Reelmaster® 450-D and 4500-D

Subject: Adding Stop Plate prevents cylinder contact on Floating Cutting Units.

Floating Cutting Unit Stop Plate (93-7774) for REELMASTER 450-D and 4500-D

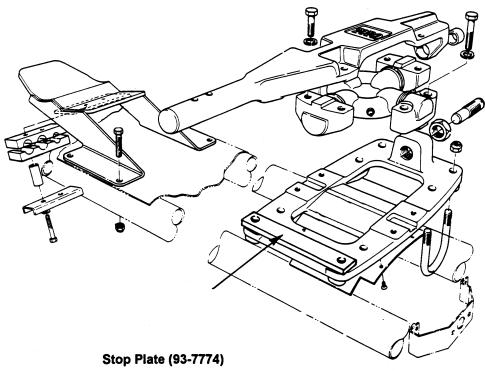
When turning around during cross cutting or any time the outside Cutting Units are raised only a few inches from the ground, the motion of the machine may cause the Cutting Unit to swing and make contact with the Lift Cylinder Body. This contact generally causes no structural damage to the cylinder or cutting unit when operated with appropriate care. However, Stop Plate (93-7774) is now available to prevent contact between the Cutting Units and the Lift Cylinder if this condition is of concern.

The view below shows the installation of the plate. Stop Plate (93-7774) is available through your local Toro distributor.

Note: Controls forward motion to prevent Cutting Unit and Lift Cylinder contact.
